public comment - PC Hearing 2/26/15, File No. 14-1617, Dixon Ranch

RE: **Dixon Ranch Draft EIR Public Comment** (A11-0006, Z11-0008, PD11-0006, & TM11-1505)

Excerpt from Figure III-5 (pdf pg,55/394)

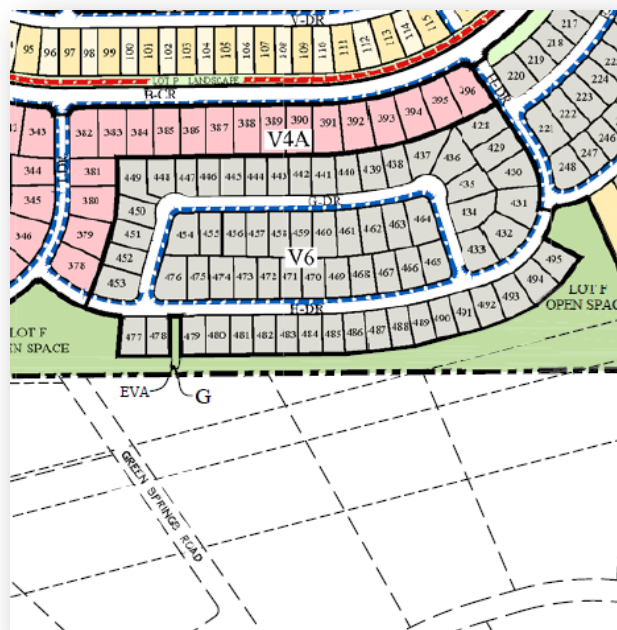
Contrary to this statement, the highest density lots are actually placed adjacent to the 5 acre parcels in Green Springs Ranch. This inconsistency with the DEIR statement and policy 2.5.1.1 is easily seen on DEIR Figure III-5:

-How is the project consistent with General Plan policies 2.2.1.2, 2.5.1.1 regarding density transition?

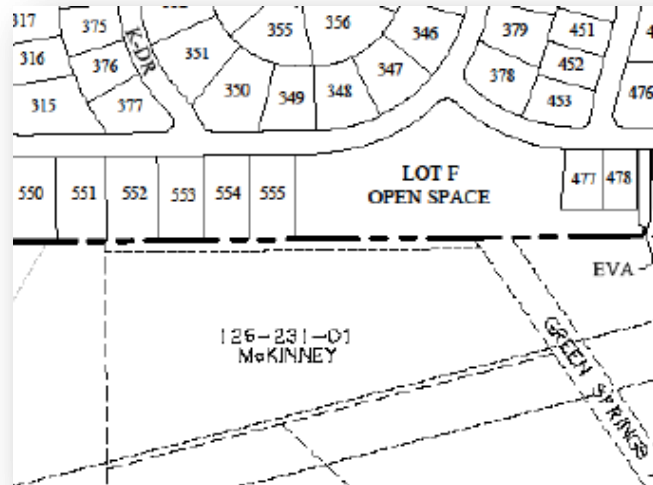
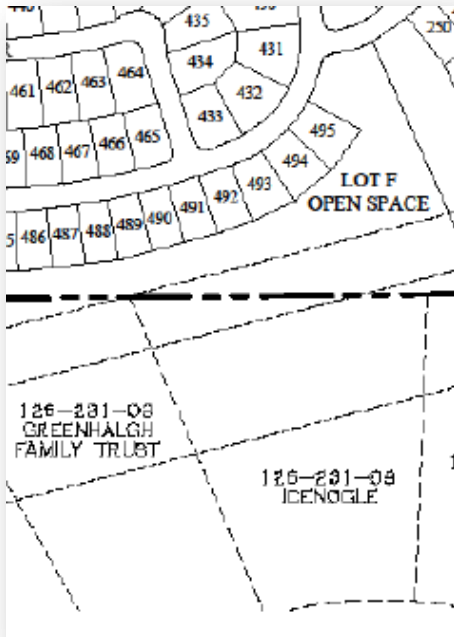
- a) The project site is itself currently zoned for agricultural use, and many of the adjacent rural properties also currently have agricultural uses. The DEIR asserts that there is adequate buffer between the project and the existing agricultural uses on the surrounding properties (pg 98; pdf version 106/394), however, these properties are not identified and buffer distances are not given. The property shown below (APN 126-291-09) is one such example where a vineyard exists. Some properties such as APN 126-231-01 are shown with zero buffer provided.

-Please identify the existing agricultural uses on adjacent properties, such as the multiple vineyards and lavender farm, and specify the minimum buffer distances proposed. How specifically is the project consistent with General Plan policy 2.2.5.21?

-Where a 'zero' setback is proposed, such as the McKinney lot pictured above, explain how this is consistent with General Plan policies requiring density transitions and buffers.

Figure 3 Soils Map⁸

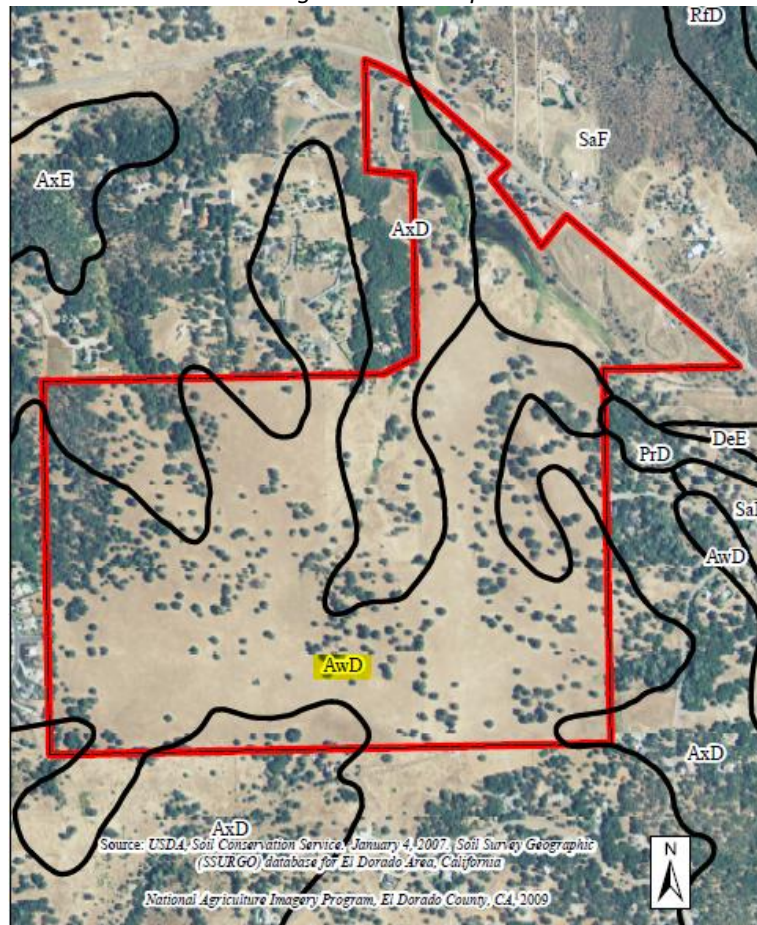
This project site is 280 acres of viable agricultural land with choice soils. Conversion of the site to non-agricultural use has very specific requirements for replacement and mitigation under both CEQA and General Plan policy 8.1.3.4.

- Where does a comparable site for agriculture exist within the El Dorado Hills area?
- How is the loss of this agricultural acreage to be mitigated?
- How has the project met the requirements of policy 8.1.3.4?
- The impacts and mitigation table in the Summary (Table II-1) must be revised.

From DEIR Figure IV-D.1 (pdf pg167/394)

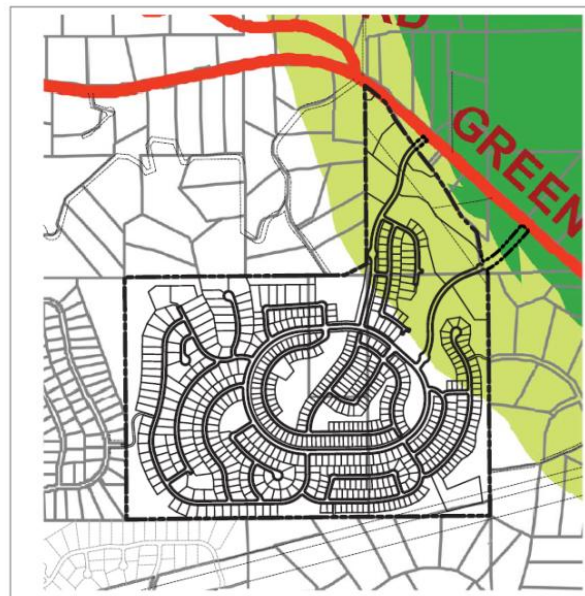
The information scattered throughout the DEIR and buried in the appendices does not show a good faith reasoned analysis. Please clearly show in the Hazards section where asbestos was found on site, so that Figure IV-D.1, Fig A-2, and Table 1 are in proximity of each other in the DEIR. Assess the need for avoidance, consider additional testing, and provide specific mitigations which include notification to the public of when grading activities in the affected area will occur.

If risk is indeed small, please provide data to back this up, or acknowledge the risk and provide true mitigations. Burying information in the almost 1200 pages of appendices only serves to make me suspicious and concerned.

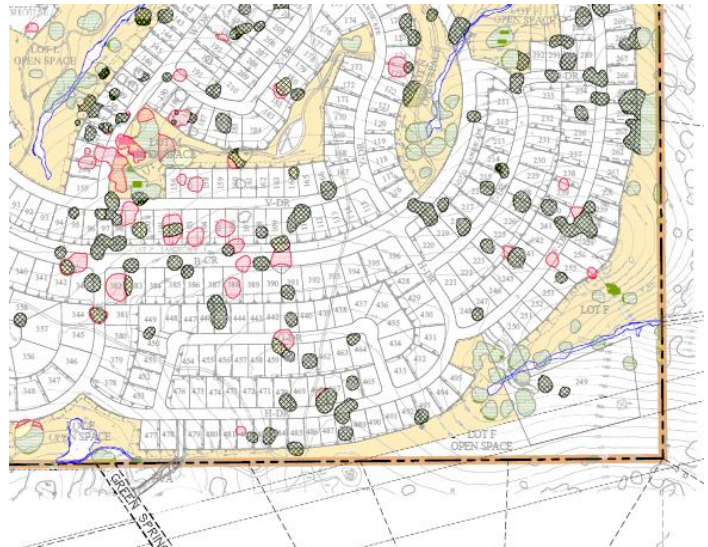
36. The 'Scenic Vista' section of the DEIR concludes that because the view is not blocked there is no impact. This is akin to suggesting that development on Yosemite's Half Dome would have no impact because the view of Half Dome would not be obstructed. This is the conclusion on DEIR page 348 (pdf 356/394):

This conclusion disregards the changes to the landscape itself. The elimination of rural landscape is a quality of life issue impacting multitudes of corridor users who drive Green Valley Rd, as well as residents on private parcels surrounding the site. This would not be an issue if the property were developed as low density in accordance with the existing General Plan land use designation.

**-How does the project propose to mitigate the visual impact of this urban expansion into the Rural Region?
-I did not see a sound wall plan. Please clarify if sound walls are to be included along Green Valley Rd and provide details such as height and setback. Also include the 22' retaining wall at access Dr A if there is to be one. This was unclear.**
